## The Rohner Residence Addition

**Site Plan**

# HOWARD COUNTY HEALTH DEPARTMENT

RE: Building Permit Application  
Serial Number 59239  
Attached deck

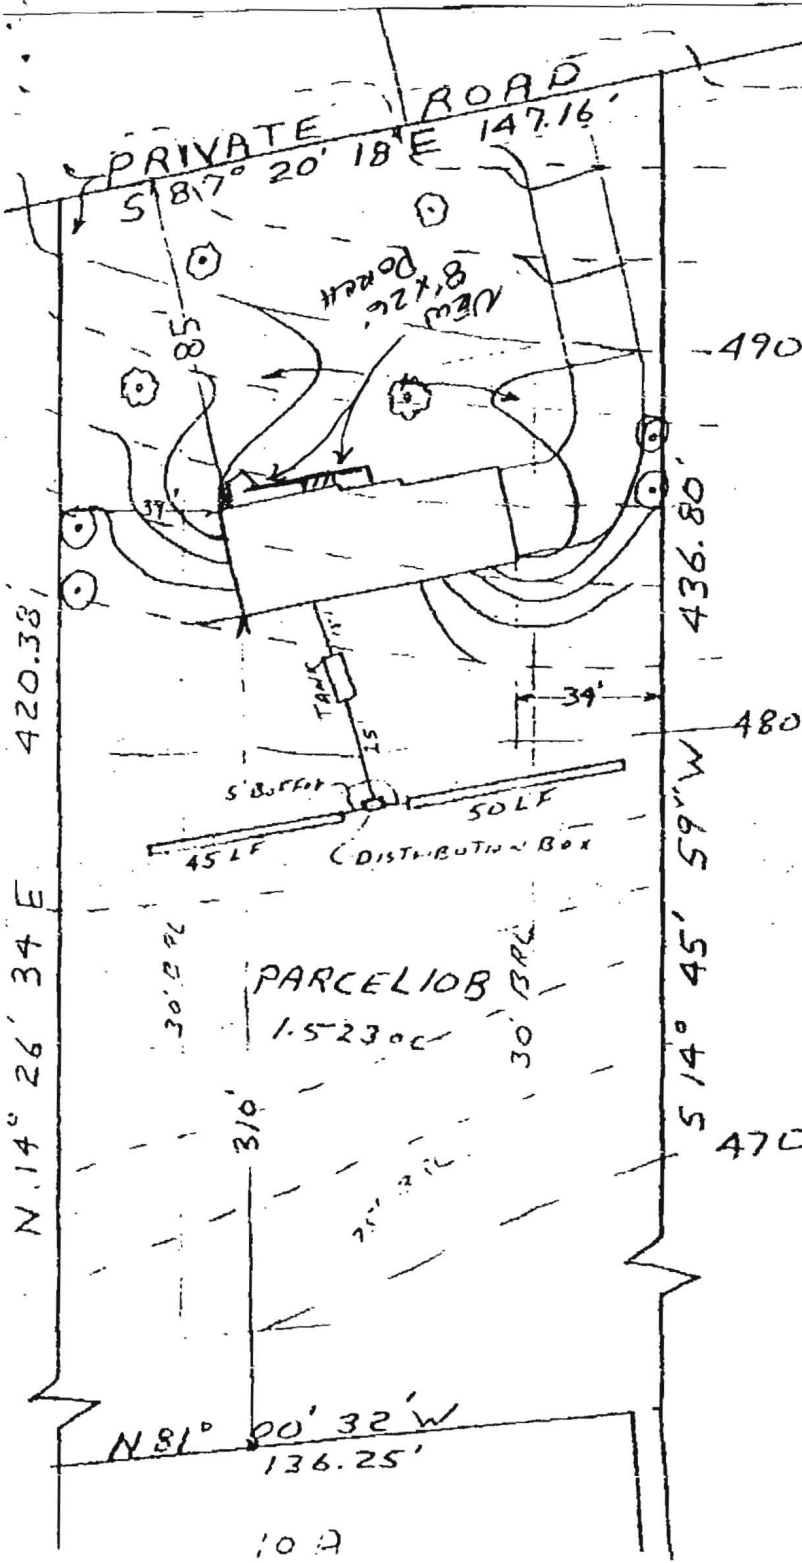
9/4/03 Proposed Addition OK (SO)

5/28/03  
 No well or  
 Septic issues  
 Both permit  
 OK  
 B00142109  
 KN

PLOT PLAN

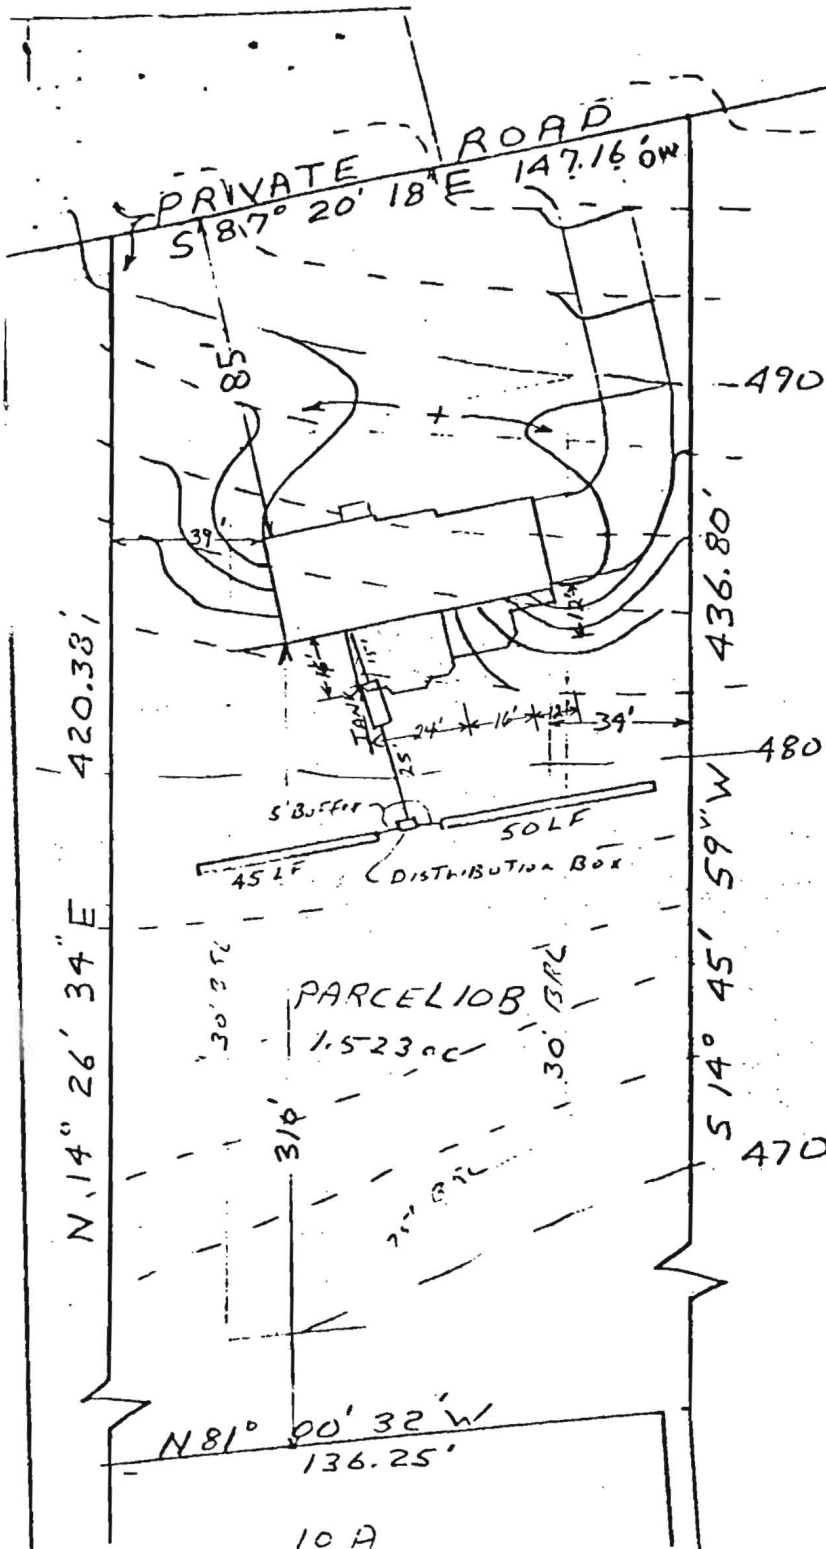
As the deck upright supports will be over the septic tank, this office cannot approve this permit with the proposal as shown on your sketch plan. If the supports or size of the deck were modified, we could re-evaluate this application.

6/21/84  
 Deck support will  
 be over septic tank  
 B.P. 59239 demand  
 J.S.
